4709 ROOSEVELT WAY NE

SDCI # 3038322-EG | MUP # 3036766-LU

RECOMMENDATION MEETING

01.30.2023

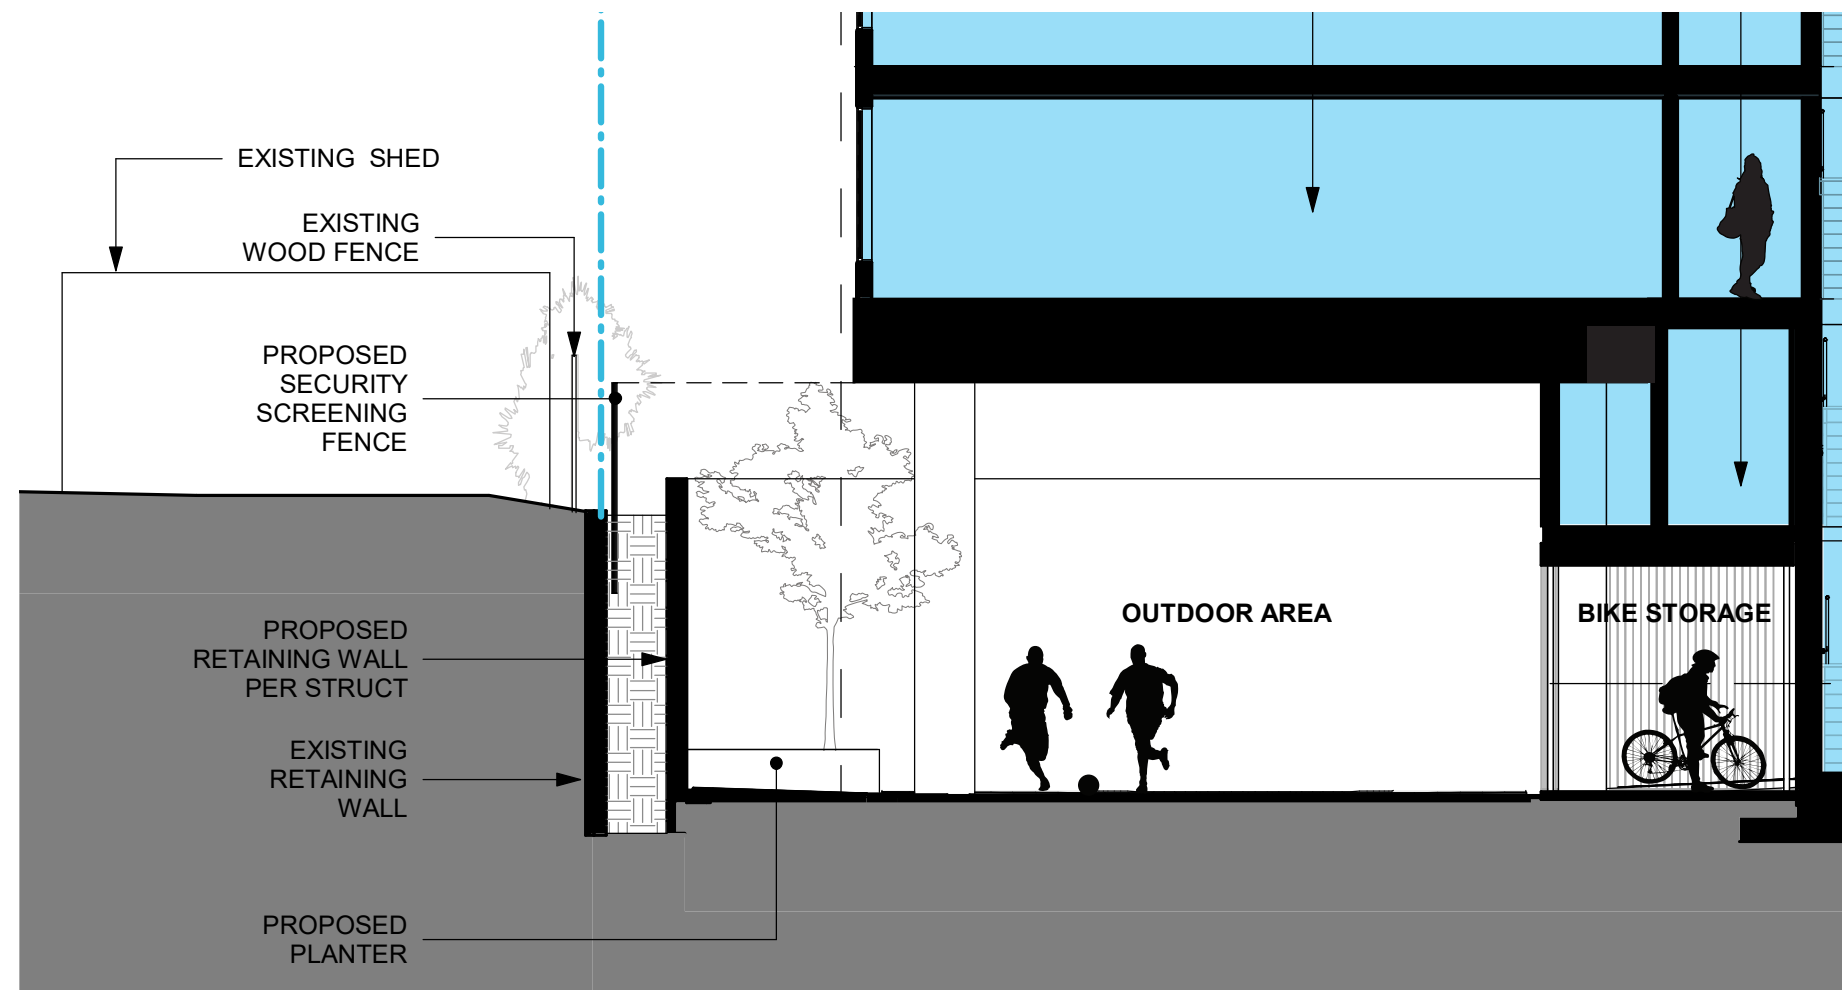
a. The Board supported the reduction in building scale at the top of the building noting that this feature was nicely done. The Board members found the setback of the rooftop amenity space to the west edge of the building helps to soften this edge to the neighboring residences and provides an opportunity to create a planting buffer. (CS2-D-5, University Supplemental Guidance CS2-2-b)

The board supported roof top terrace concept is maintained. The planting buffer concept is maintained. The angled cable mesh guard is integrated with the planter buffer to provide safety but be visually minimal and blend in with the planting rather than a "fenced in" roof terrace.

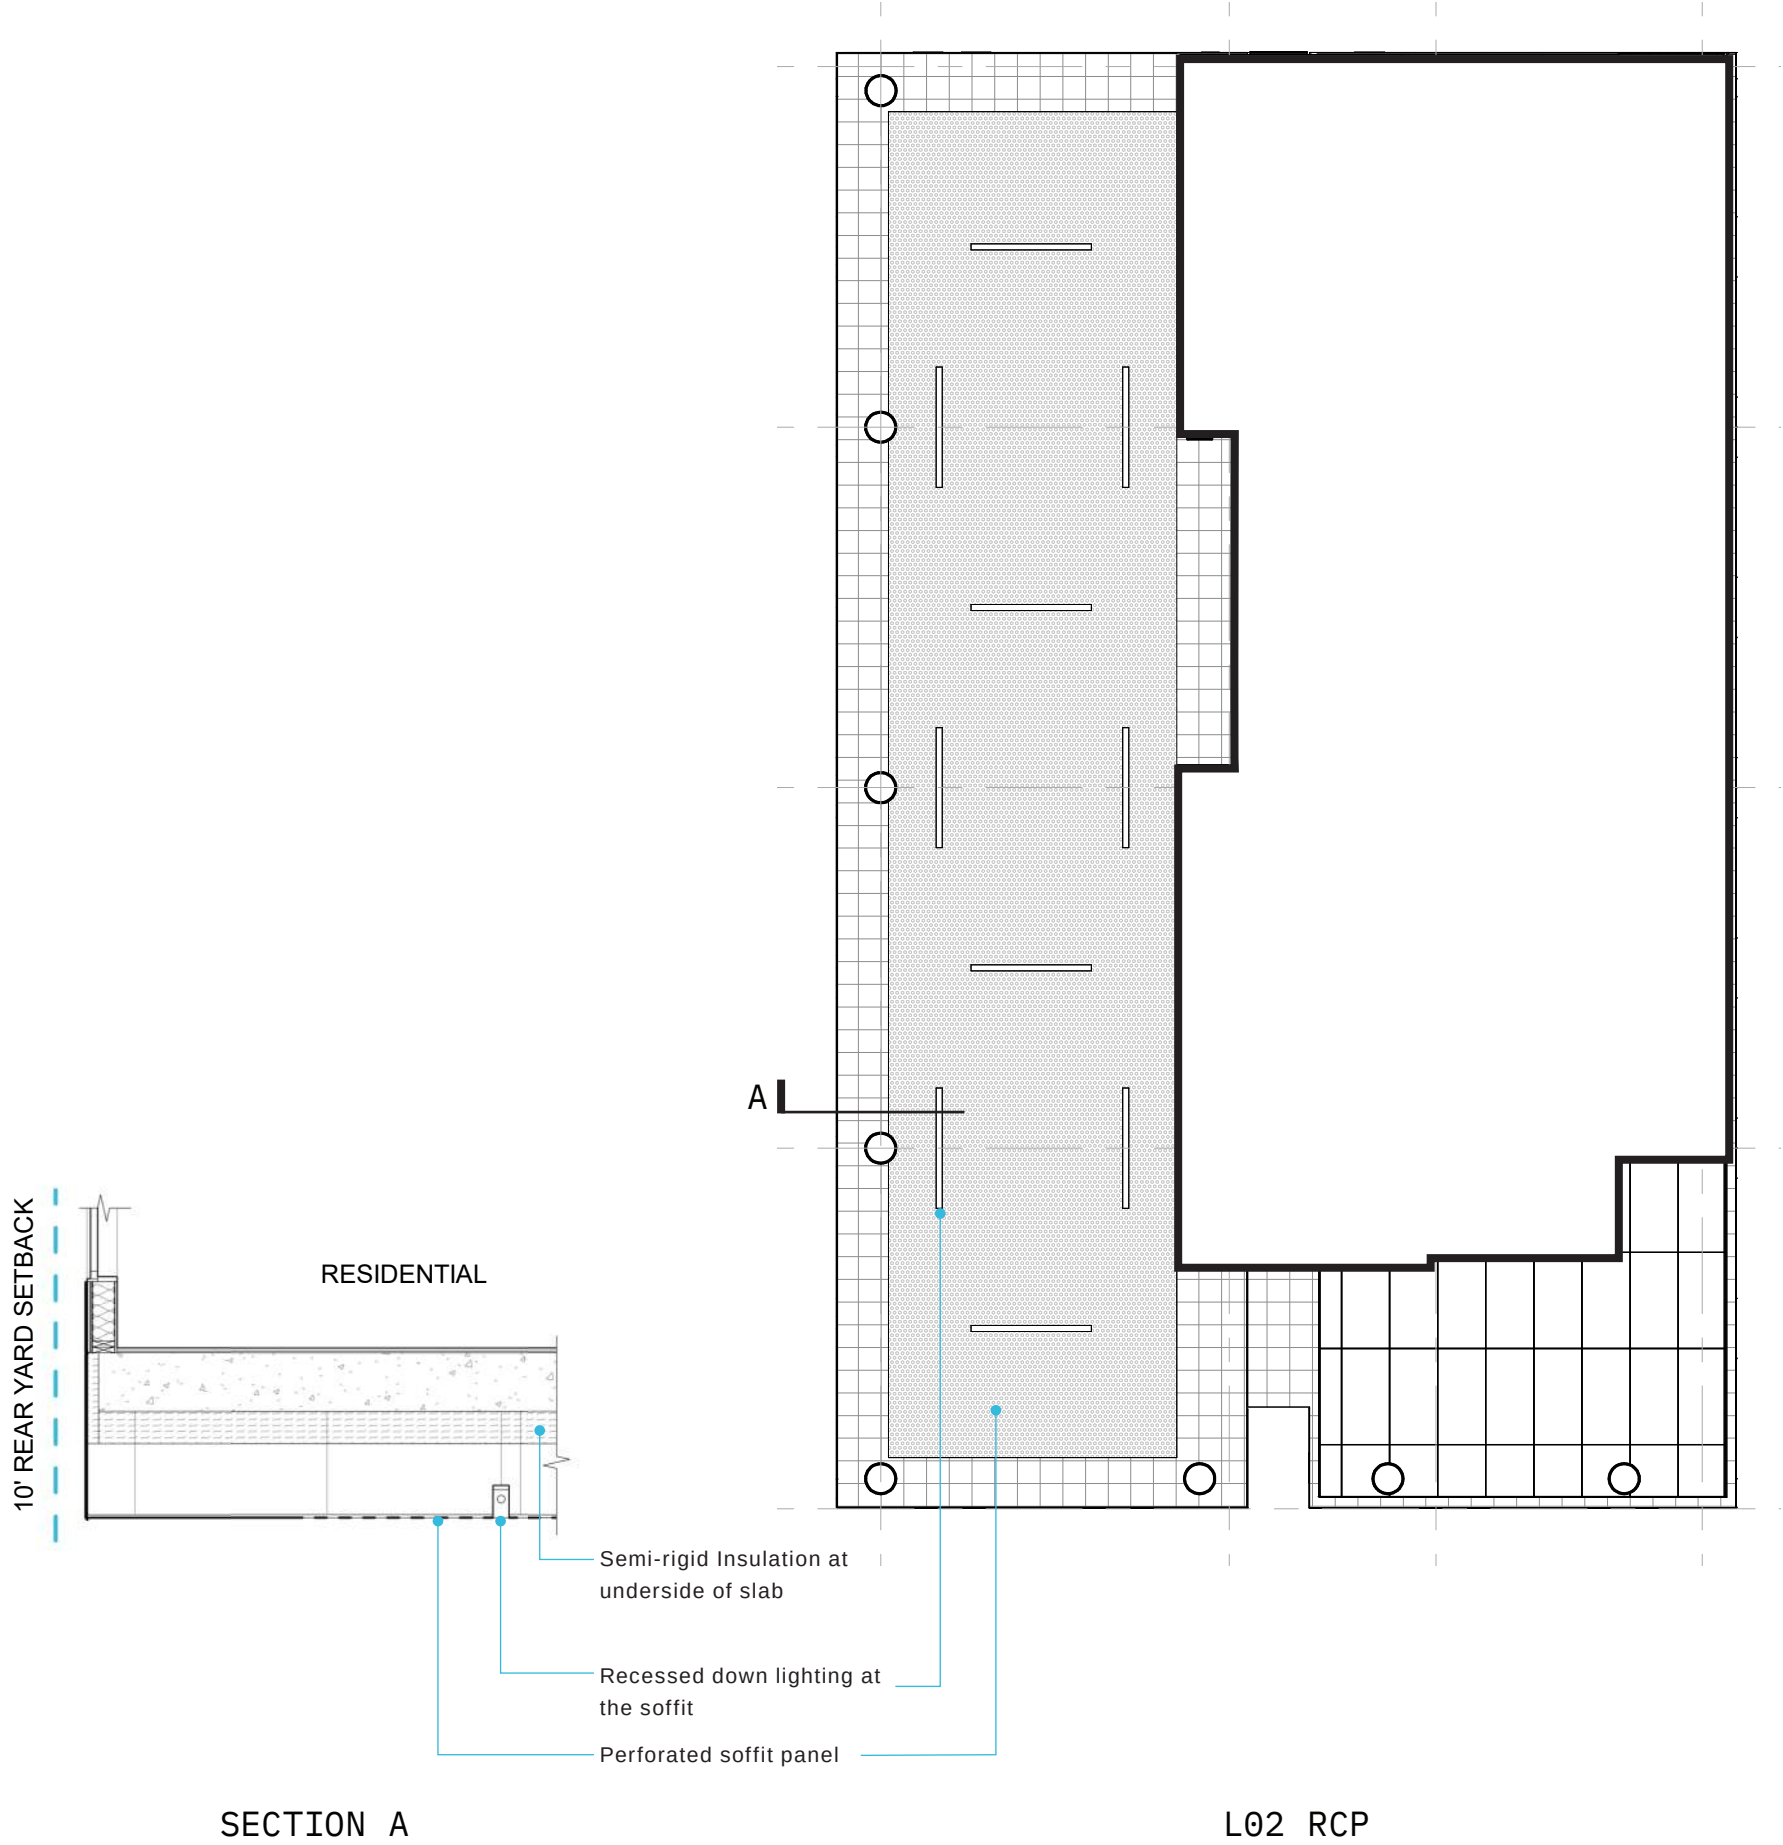
c. Board members had concerns with the light and noise impacts the ground level amenity space could create when completed. The Board recommended the applicant include light and noise studies at the ground level in the Recommendation packet to provide the Board with a better understanding of what these impacts would be to the adjoining properties to the west. (DC4-C)

Design Response:
The concept proposes a perforated soffit at the recreation area per the direction of the design team's acoustical consultant. The perforated soffit would allow sound to be absorbed into the insulation layer behind the soffit board. The reflected ceiling plan to the left shows the extent of perforated cement panel soffit. The detail section shows the insulation layer above the perforated panel that would absorb sound from below.

Linear down lighting is proposed for the recreation area and would conform to SMC 23.47A.022 - Light and glare standards. Liner lighting is shown to the left on the reflected ceiling plan.

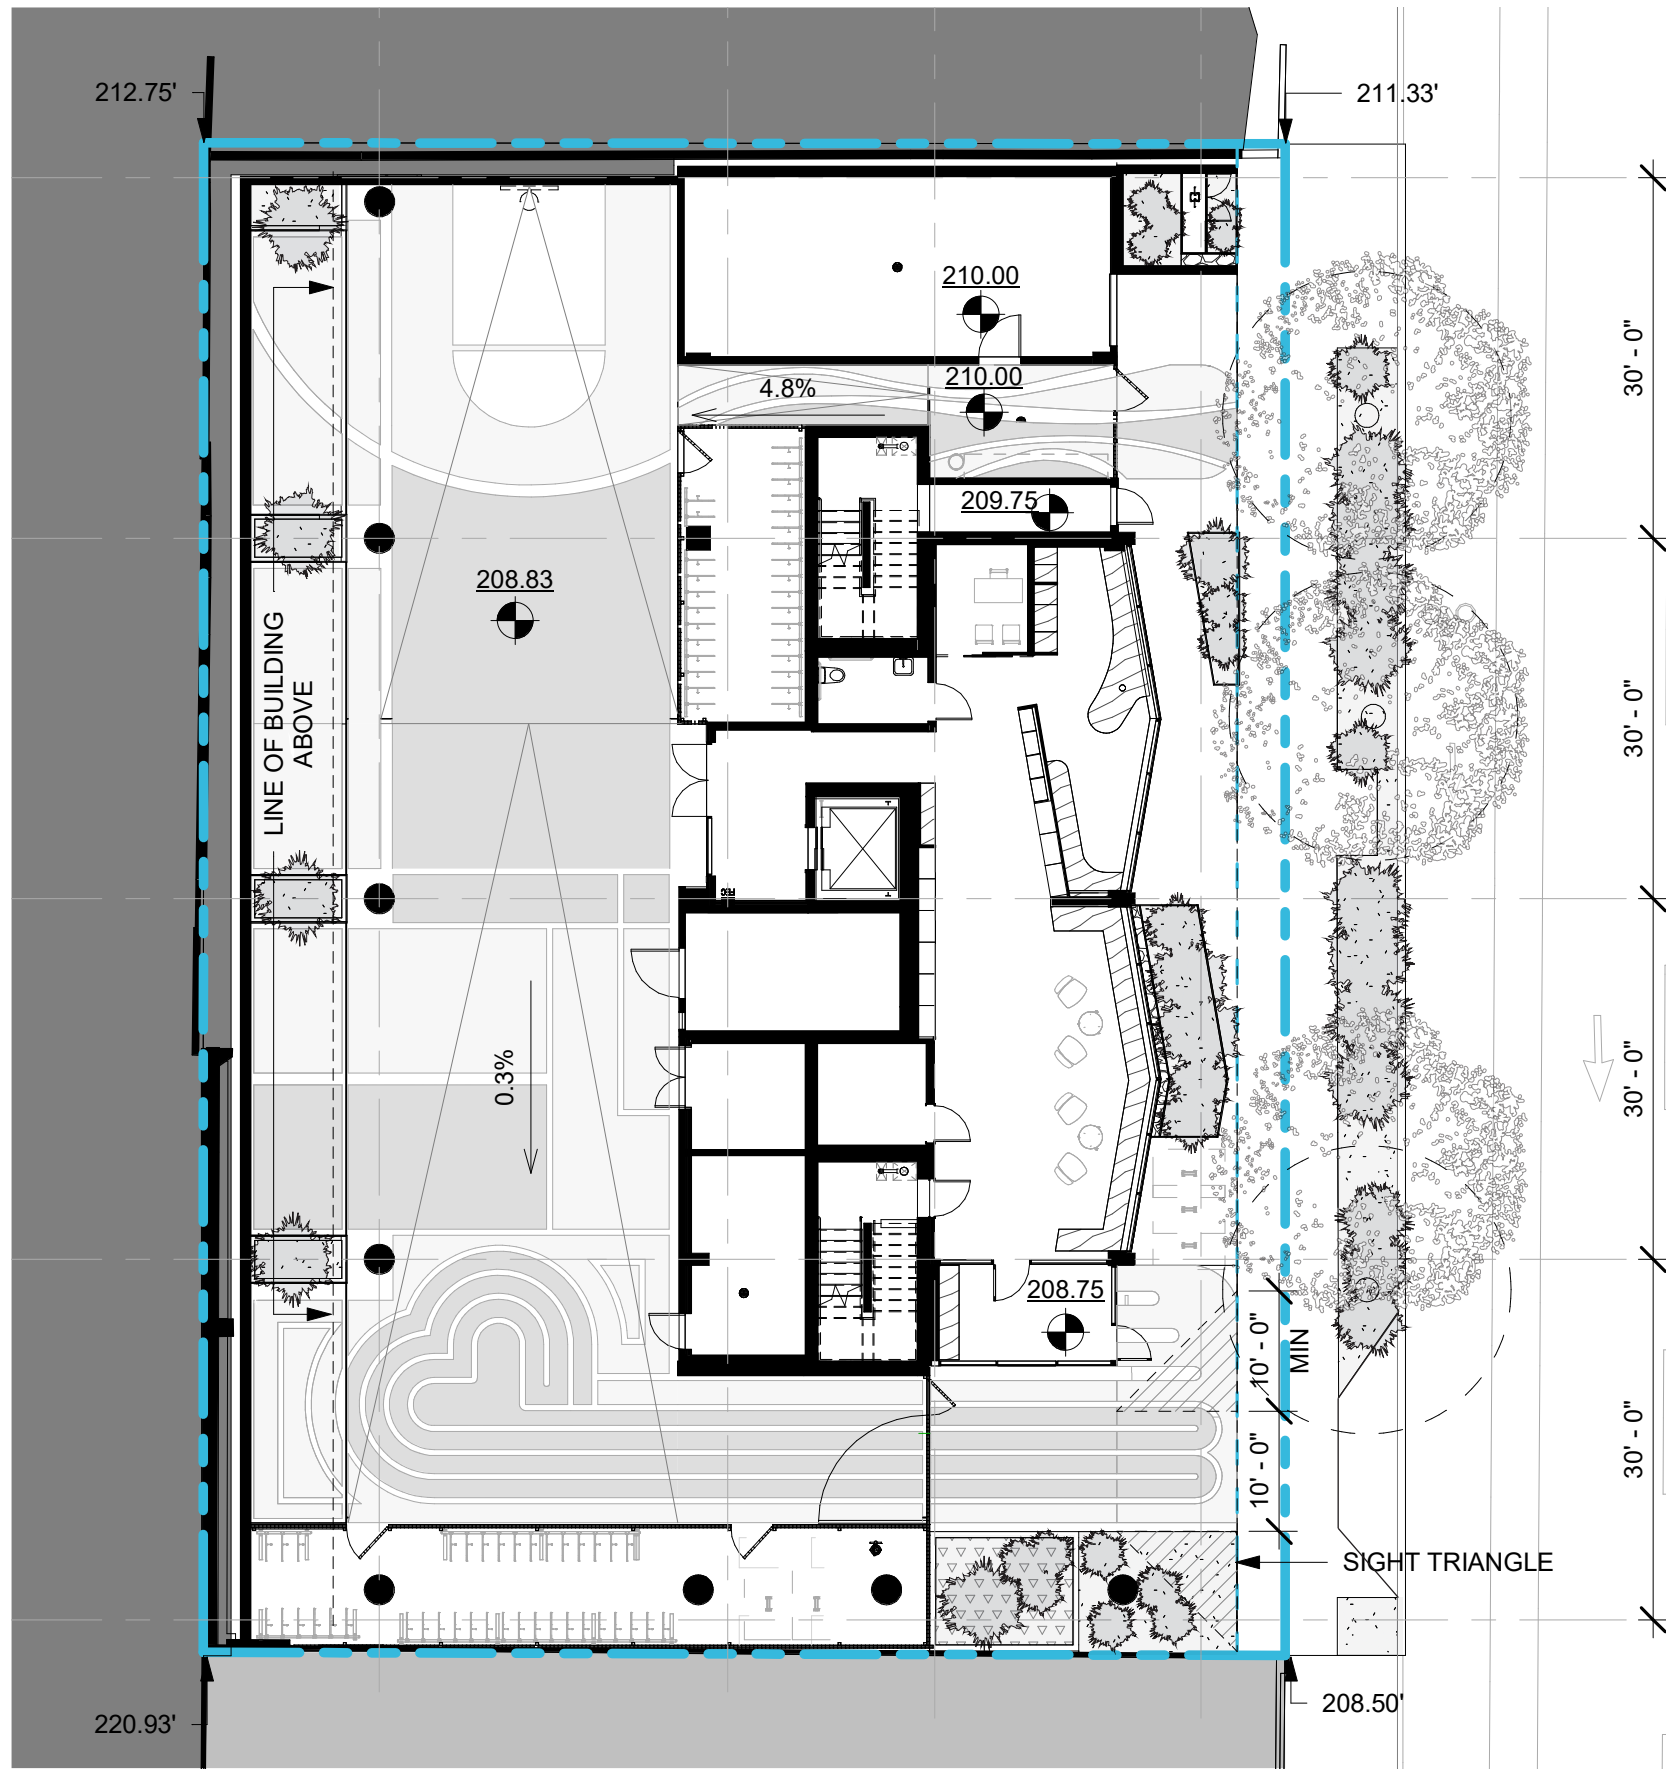
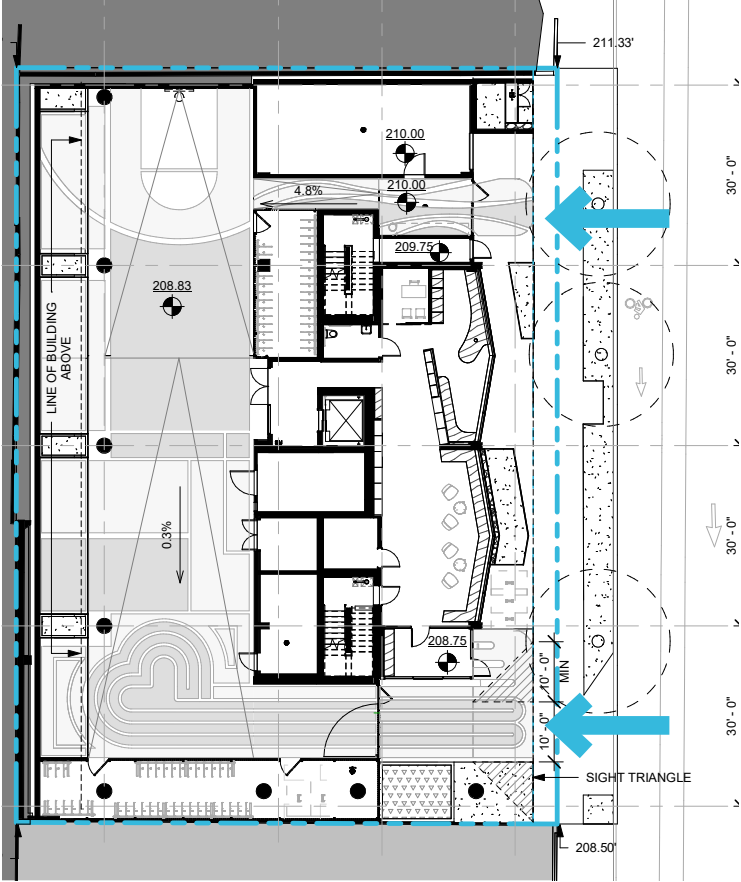
a. The Board supported removing the ground level parking shown in the initial EDG packet. The relocation of the main pedestrian entrance to the south side of the site was also supported by the Board. (PL3-A-1)

The Board supported location the south pedestrian entrance is maintained.

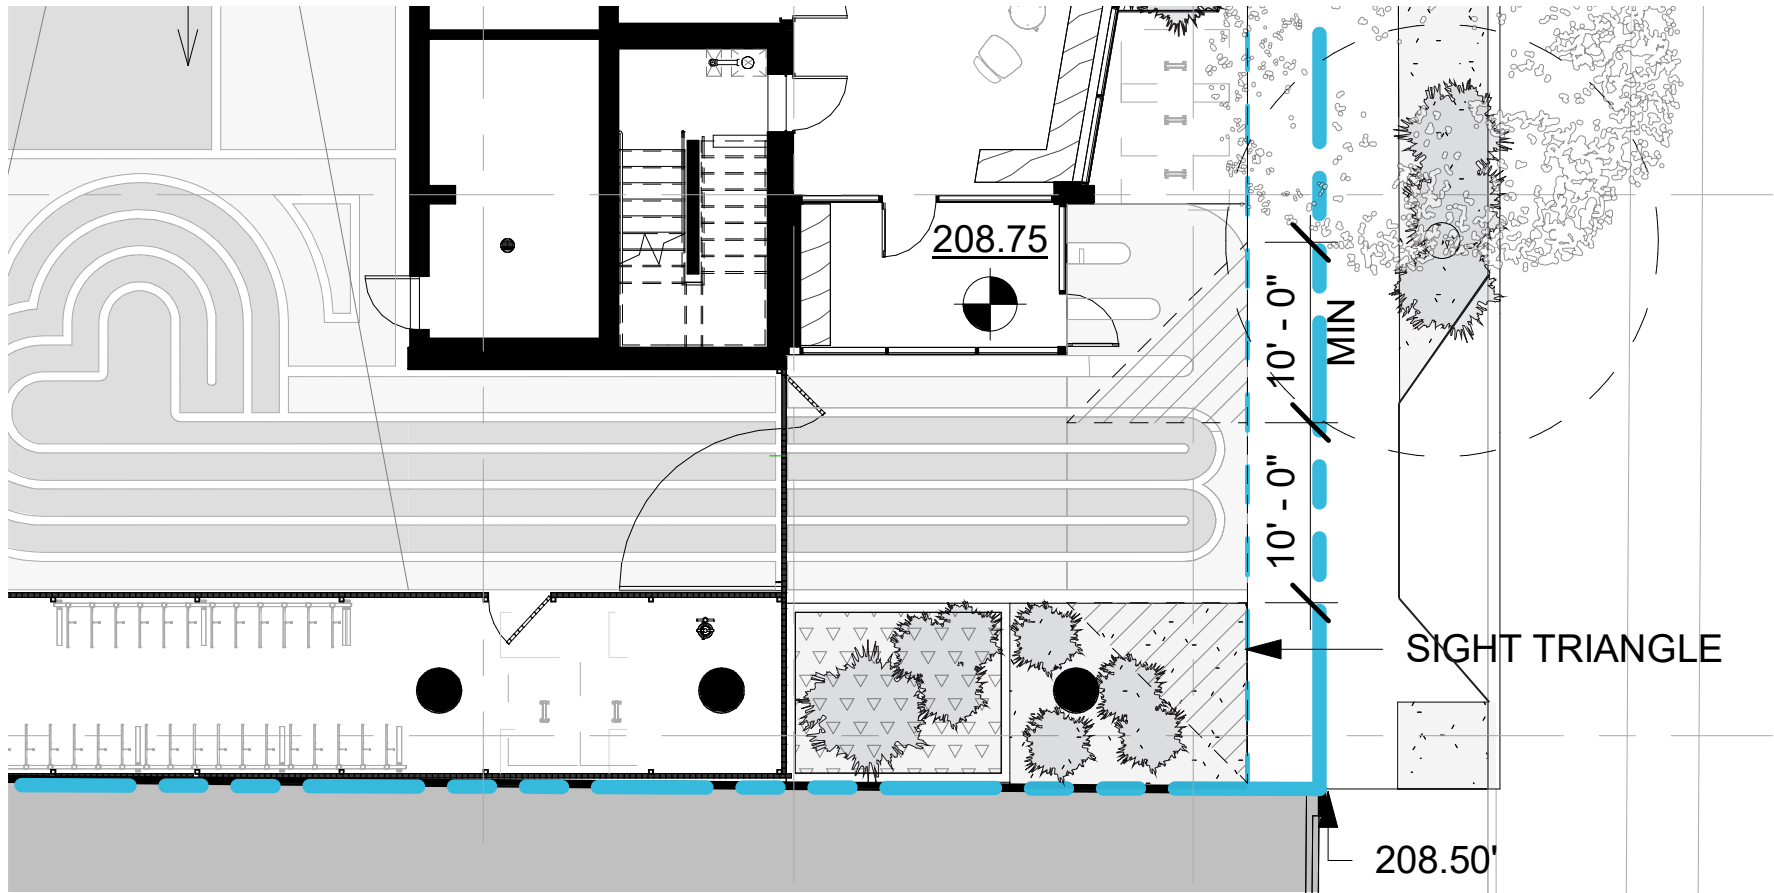
c. The Board supported the flexible space provided at the street level and the applicant’s approach to permit this space to be adapted later for commercial purposes. As noted under the Site Analysis section of this report, the Board requested the applicant explore how an expanded commercial space could be accommodated at the street level. (DC1-A, University Supplemental Guidance PL3-3-f)

Design Response:
Due to density limits (FAR) of the zone and the project’s design goal to "maximize places for people to live" requires the project to minimize all interior gross floor area that is accessory to the residential use, services and support areas. If the project were to expand interior space for a future potential commercial area, the project would have to reduce places for people to live - i e reduce the amount of apartment area to expand street level lobby area.
